LEIGHTON COMMONS SUBDIVISION

APPLICATION NUMBER 6 DATE October 6, 2005
APPLICANT Leighton Commons Subdivision
REQUEST Subdivision

DETAIL SITE PLAN

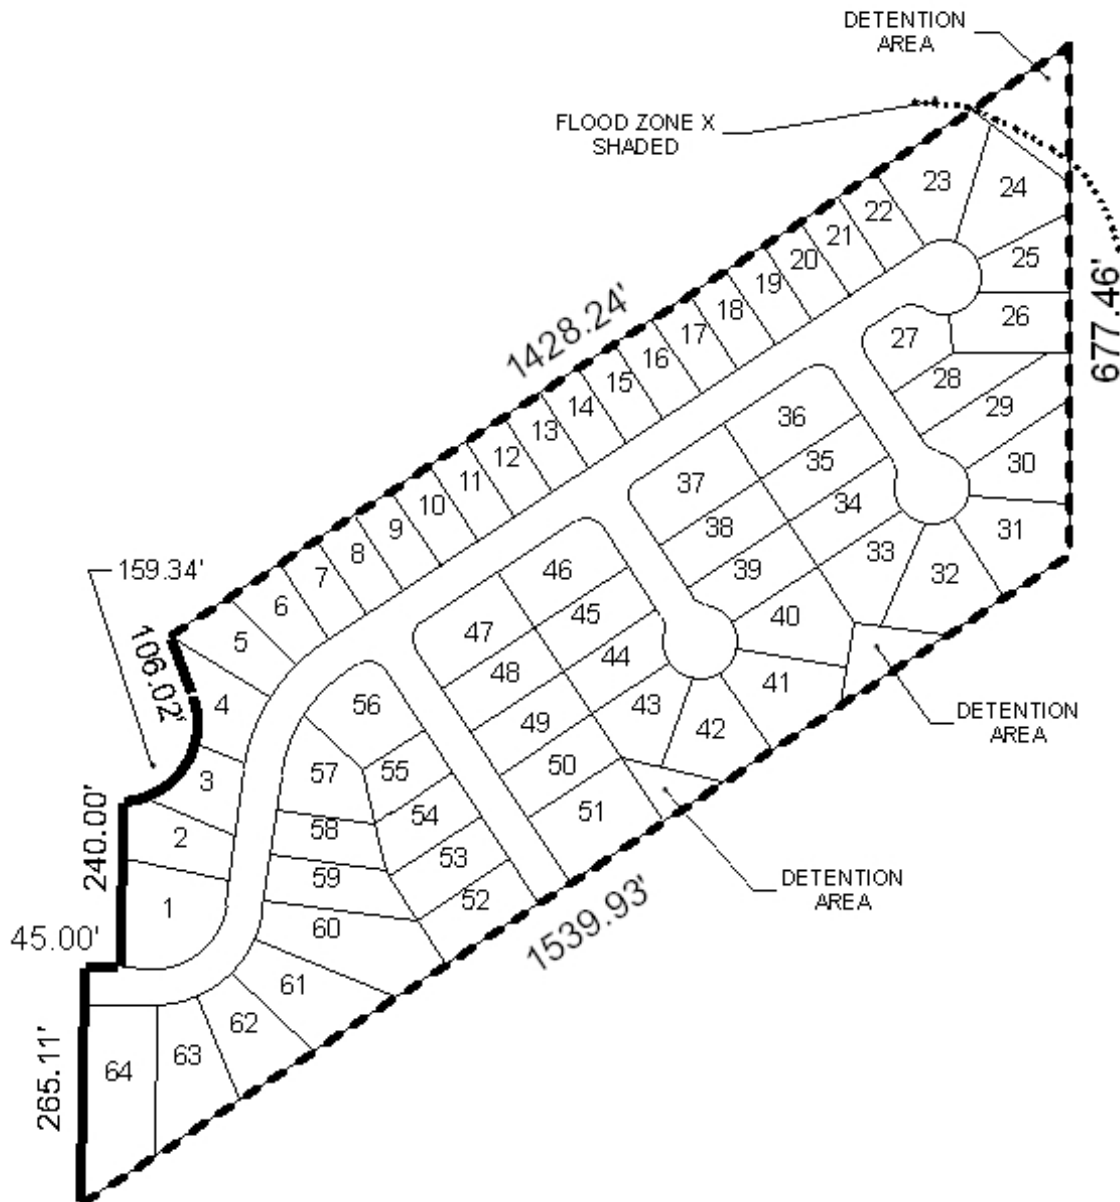
The subdivision lots meet minimum size requirements, however, the 25-foot minimum building setback line, required in Section V.D.9. of the Subdivision Regulations, is not shown for the subdivision and would be required on the Final Plat, if approved.

Lots 1-4 and Lot 64 have frontages on the internal subdivision street as well as either Riviere du Chien Road or Lloyd Station Road. Even though these are minor streets, a note should be placed on the Final Plat, if approved, stating that Lots 1-4 and Lot 64 shall not have direct access to Riviere du Chien Road or Lloyd Station Road.

The proposed subdivision, as designed, has a street-stub to the south. The preliminary plat on file for the subdivision to the south, Leighton Place, does not indicate a reciprocal street-stub to the north. Both Leighton Commons and Leighton Place (subdivision approved June 2004, with streets under construction) are being developed by the same applicant, and the applicant has stated that the two subdivisions will be linked in order to meet the egress codes of the Fire Department. The existing Leighton Place subdivision approval expired in June 2005, thus the subdivision will have to be resubmitted, and a stub to Leighton Commons will have to be shown

on the plat. Therefore, approval of Leighton Commons should be conditioned upon the provision of a public street connection from the Leighton Place Subdivision; otherwise compliance with the International Fire Code will require all residential structures to have individual sprinkler fire suppression systems.

It should also be noted that the intersection of the proposed street serving the subdivision and Riviere du Chien Road should have property line corners in conformance with Section V.D.6. of the Subdivision Regulations.

Three detention areas are proposed for the subdivision, however, there is no indication of access via easement or dedicated street to permit the maintenance and cleaning that is required for such facilities; the plat should be revised to reflect access to the detention areas, in conformance with Sections VI.C.3. and VII.B.2. of the Subdivision Regulations. Furthermore, a note should be placed on the Final Plat, if approved, stating that maintenance of the detention basin common areas, and any other common areas, are the responsibility of the subdivision's property owners.

Finally, a land-locked parcel occurs north of the site. A parcel owned by the same individual as the land-locked parcel fronts Lloyd Station Road and subsequently can provide access at this time to the land-locked parcel. However, as the land-locked parcel could be sold to a different owner, either a right-of-way stub or a 25-foot wide frontage linking the land-locked parcel to a street within the proposed subdivision should be required.

Based upon the preceding, the plat is recommended for Tentative Approval subject to the following conditions: 1) placement of a note on the Final Plat stating that Lots 1-4 and Lot 64 are denied direct access to Riviere du Chien Road and Lloyd Station Road; 2) depiction of the 25-foot minimum building setback line in compliance with Section V.D.9. of the Subdivision Regulations; 3) revision of the plat to reflect provision of access to detention areas via easement or dedicated street; 4) no permits are to be issued for street construction in Leighton Commons until a new application showing a corresponding street stub has been submitted for the expired Leighton Place Subdivision to the south; 5) adjustment of the property line corners at the street intersection with Riviere du Chien Road, in conformance with Section V.D.6. of the Subdivision Regulations; 6) revision of the plat to reflect provision of a right-of-way stub or a 25-foot wide frontage onto a street of the proposed subdivision for the landlocked parcel to the north (parcel R023306132000001.019.); 7) placement of a note on the Final Plat stating that maintenance of the detention basin common areas, and any other common areas, are the responsibility of the subdivision's property owners, and; 8) approval of all applicable federal, state and local agencies regarding the potential wetlands and floodplain issues prior to the issuance of any permits.
